DOCKET NO. **SA-510**

**NATIONAL TRANSPORTATION SAFETY BOARD**

## **737 Rudder PCU Input Rod Summary**

POWER UNIT INSTL-RUD CONT  
FIGURE 1 (SHEET 1)

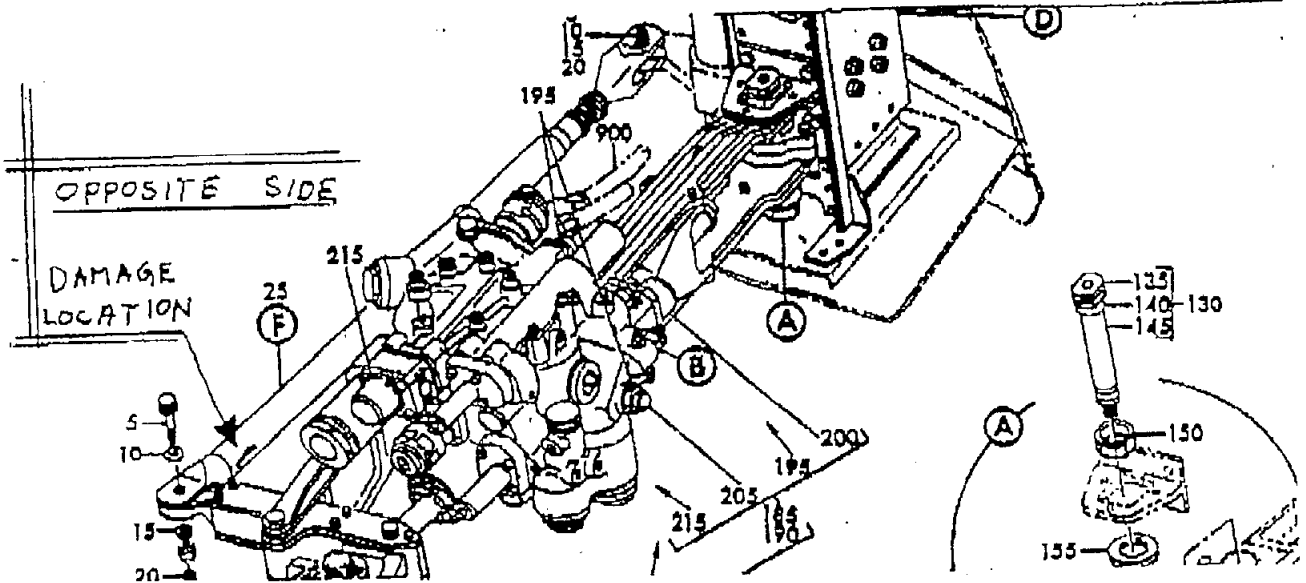
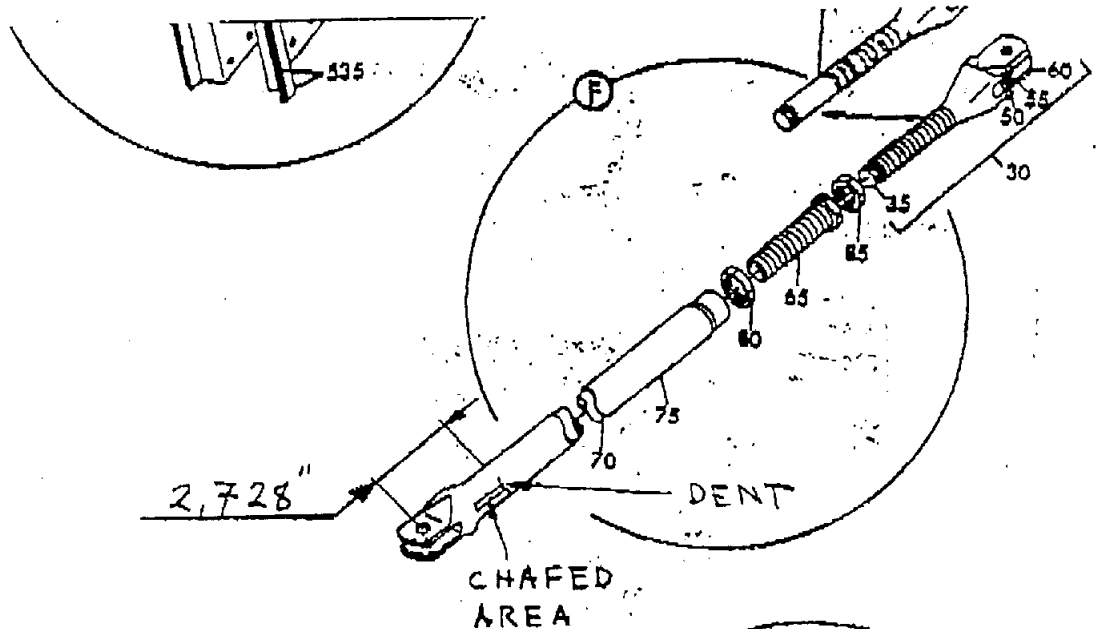
ATA 2725-30 MODEL 737-405 9 JAN 95 H  
 RUDDER PCU - VERNIER DUAL PATH ROD CHAFING WITH VERTICAL STAB  
 REF /A/ 69-37290-11 VERNIER ROD  
 /B/ IPC 27-21-91-01 ITEM 25  
 /C/ FAX - 1 PG SAME NBR THIS TELEX  
 /D/ SB 737-55-1052 23 SEP 93  
 AIRPLANE HOURS/CYCLES  
 PW571 13378/11351  
 LN-BRA

PW571 IS CURRENTLY UNDERGOING ITS FIRST "4C" CHECK. DURING THIS MAINTENANCE PERIOD, BRAATHENS FOUND THE SUBJECT ROD WITH A DENT AND CHAFING. INSPECTION SHOWED THAT CONTACT HAD BEEN MADE DURING NORMAL OPERATION WITH THE VERTICAL STABILIZER STRUCTURE.

THE DENT IS APPROXIMATELY 0.027 INCH DEEP AND IS LOCATED 2.728 INCH FROM THE CENTER OF THE MOUNTING BORE. THE CHAFED AREA IS APPROXIMATELY 1.025 INCH LONG AND 0.120 INCH WIDE, THE DEPTH IS MINOR. PLEASE SEE THE REF (C) FAX (NOTE THAT THE FAX DEPICTS THE ROD WITH THE DENT AND CHAFING ON THE INBOARD SIDE OF THE ROD - IN FACT, THE DENT AND CHAFING ARE LOCATED ON THE OUTBOARD SIDE OF THE ROD).

BRAATHENS PLANS TO LOCALLY BLEND AND POLISH THE DENT AND CHAFING, EDDY CURRENT INSPECT, TREAT WITH ALODINE, AND PRIME WITH BMS 10-11.

AFTER INSTALLATION OF THE PCU, IF CLEARANCE BETWEEN THE SUBJECT VERNIER ROD AND THE FIN STRUCTURE SEEMS INADEQUATE, BRAATHENS HAS SUGGESTED ACCOMPLISHING THE REWORK DESCRIBED IN THE SB ON THE LEFTHAND SIDE OF THE FIN.

1. PLEASE PROVIDE A "NO TECHNICAL OBJECTION (NTO)" STATEMENT FOR THE BRAATHENS' PROPOSAL TO REWORK THE SUBJECT ROD AND RETURN TO SERVICE.
2. PLEASE COMMENT ON KNOWN REPORTS BY OTHER OPERATORS WITH SIMILAR EXPERIENCE.
3. PLEASE COMMENT ON THE BRAATHENS' PROPOSAL TO ACCOMPLISH A CUTOUT, SIMILAR TO THAT DESCRIBED IN THE REF (D) SB, ON THE LEFTHAND SIDE OF THE FIN.
4. IN ORDER TO SUPPORT THE MAINTENANCE SCHEDULE, PLEASE MAKE BEST ATTEMPT TO RESPOND BY 9 JAN 95.

1. OUR REVIEW OF THE REF /A/ AND REF /D/ INFORMATION INDICATES THAT IT IS STRUCTURALLY UNACCEPTABLE TO CONTINUE USE OF THE DAMAGED INPUT ROD DUE TO POTENTIAL COMPRISE OF THE DUAL LOAD PATH FUNCTION OF THIS ROD. ACCORDINGLY, WE SUGGEST THAT THE DAMAGED INPUT ROD BE REPLACED.

2. WE HAVE RECEIVED REPORTS FROM OTHER OPERATORS OF SIMILAR RUDDER PCU INPUT ROD DAMAGE. HOWEVER, IN EACH OF THESE REPORTS, THIS DAMAGE WAS ATTRIBUTED TO TESTING OR REMOVAL ANOMALIES. ONE OF THESE REPORTS STATED THAT THE DAMAGE OCCURRED WHEN THE RUDDER PCU WAS DISCONNECTED FROM THE RUDDER WITHOUT FIRST REMOVING THE RUDDER PCU INPUT ROD AS SPECIFIED IN MM 27-21-11. OUR REVIEW OF AVAILABLE DATA DID NOT REVEAL ANY PREVIOUS SIMILAR REPORTS WHICH WERE ATTRIBUTED TO INTERFERENCE DURING NORMAL OPERATION.

3. MODIFICATION OF THE LEFT SIDE VERTICAL FIN STRUCTURE SIMILAR TO THAT DISCUSSED IN THE REF /E/ SERVICE BULLETIN WOULD REQUIRE FURTHER EVALUATION BEFORE APPROVAL. WE SUGGEST THAT BRT REINSTALL THE RUDDER PCU AND INPUT ROD, AND CHECK THE MINIMUM CLEARANCE BETWEEN THE ROD AND ADJACENT STRUCTURE THROUGH FULL RUDDER PEDAL TRAVEL. THIS SHOULD BE DONE WITH THE RUDDER PCU FULLY POWERED. IF A POTENTIAL INTERFERENCE CONDITION EXISTS, PLEASE ADVISE US THE MINIMUM CLEARANCE OR DEGREE OF INTERFERENCE. WE WILL EVALUATE STRUCTURAL MODIFICATIONS FOLLOWING RECEIPT OF THIS INFORMATION.

FIG 1  
TOP VIEW

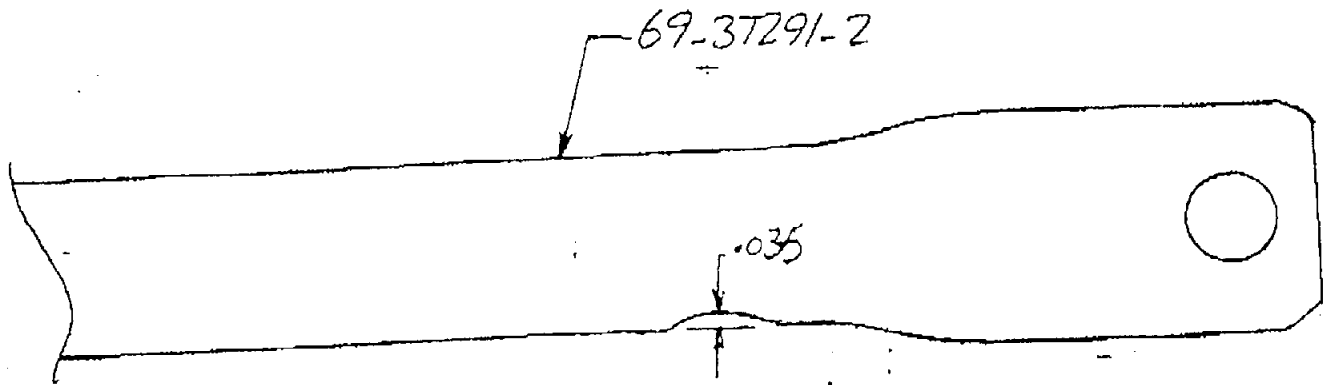
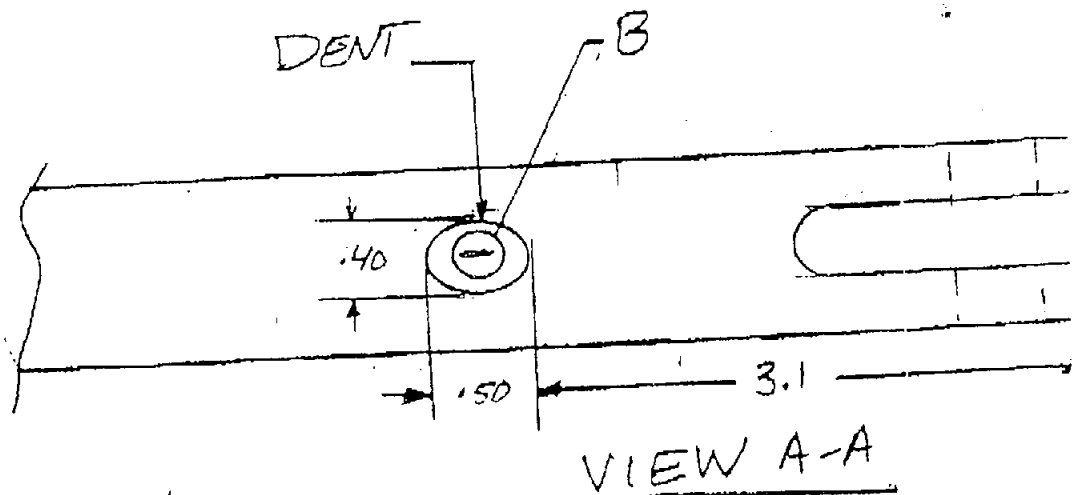
THE OUTER ROD P/N 69-37291-2 WAS DENTED  
WHEN THE RUDDER ACTUATOR WAS ACCIDENTALLY OPERATED  
WHILE THE RUDDER WAS REMOVED FOR BALANCING.  
THE ROD WAS FORCED AGAINST AN ADJACENT STRUCTURE  
WHICH CAUSED A SMALL DENT AND A CRACK (Ref FIG 1)

1- CAN THE DAMAGED AREA BE REPAIRED? OR IS IT  
RECOMMENDED TO CHANGE THE ROD?

GAUGE IS  
MAX .015 DEEP.

IN THE REF /A/ FAX PEMCO REPORTED THE THAT OUTER RUDDER PCU INPUT ROD P/N 69-37291-2 BECAME DENTED WHEN THE RUDDER PCU WAS INADVERTENTLY OPERATED WHILE THE RUDDER WAS REMOVED FOR BALANCING. THE ROD WAS FORCED AGAINST AN ADJACENT STRUCTURE WHICH CAUSED A SMALL DENT. PEMCO ASKED WHETHER THE DAMAGED AREA IS REPAIRABLE OR THE ROD MUST BE REPLACED.

THE ROD IS STRUCTURALLY ACCEPTABLE IF REPAIRED PER THE FOLLOWING INSTRUCTIONS.

1/ BLEND-OUT THE DAMAGED AREA. THE MAXIMUM ALLOWABLE DEPTH OF MATERIAL REMOVAL IS 0.018 INCHES. MINIMUM RADIUS OF BLEND-OUT IS 0.25 INCHES.

2/ RADIUS THE EDGES OF THE DENT TO A MINIMUM OF 0.15 INCHES.

3/ SURFACE ROUGHNESS OF MACHINED SURFACES SHALL BE 63 MICROINCHES OR BETTER.

4/ AFTER MACHINING, PENETRANT INSPECT PER OHM 20-20-02.

5/ ALODINE PER OHM 20-43-03.

6/ FINISH WITH ONE COAT BMS 10-11, TYPE I WET PRIMER.

DELTA (DAL) REPORT (DAL-ATL-95-0114TR)

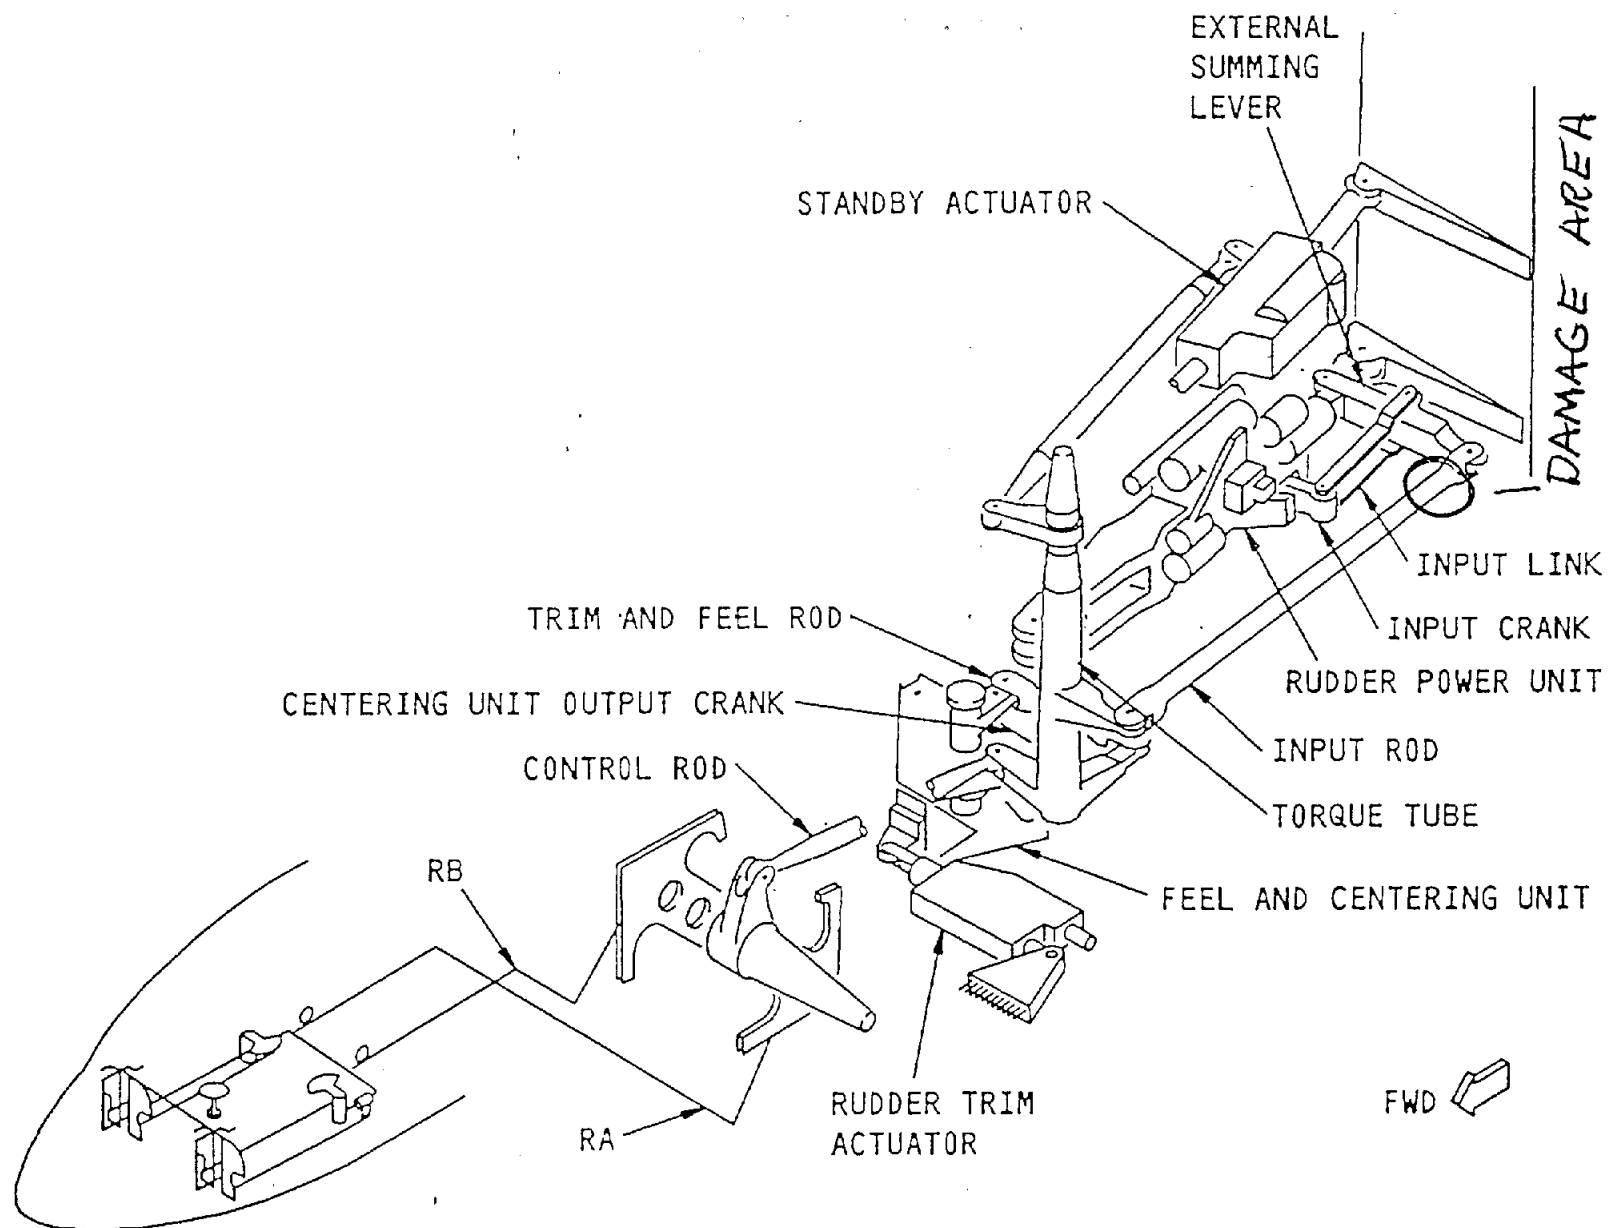
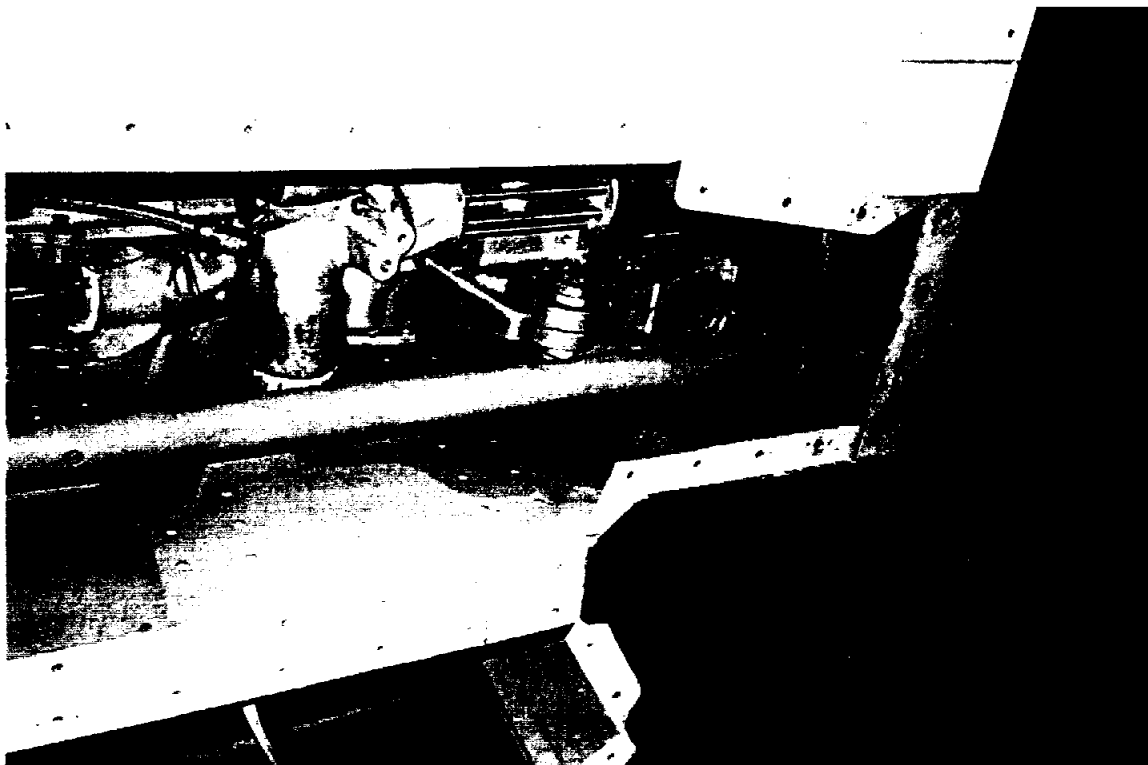
DURING THE PRESENT HMV OF THE DATA AIRPLANE, A DAMAGED INPUT ROD TO THE RUDDER PCU WAS DISCOVERED. DAMAGE HAS OCCURRED AT THE AFT END OF THE ROD WHERE THE ROD HAS BEEN STIKING THE LEFT AFT VERTICAL FRAME STRUCTURE OF THE STABILIZER. UPON NOTIFICATION, PICTURES WERE TAKE WITH ALL COMPONENTS IN PLACE. THE PICTURES HAVE BEEN SENT BY AIRBORNE EXPRESS AIRBILL 8770295332. THIS OFFICE HAS ASKED FOR THE INPUT ROD AND THAT THE RUDDER PCU BE MADE AVAILABLE IF BOEING REQUESTS. THE REF /B/ SKETCH SHOWS DAMAGE LOCATION. THE DENT IN THE INPUT ROD IS APPROXIMATELY 1/4 INCH DEEP AND IS SCRAPED REARWARD ABOUT 1 INCH. THERE IS A MINOR INDICATION OF SCRAPING ON THE VERTICAL RUDDER STRUCTURAL ELEMENT.

ACTION: PLEASE ADVISE IF BOEING WOULD LIKE TO EXAMINE THE RUDDER PCU OR THE INPUT ROD.
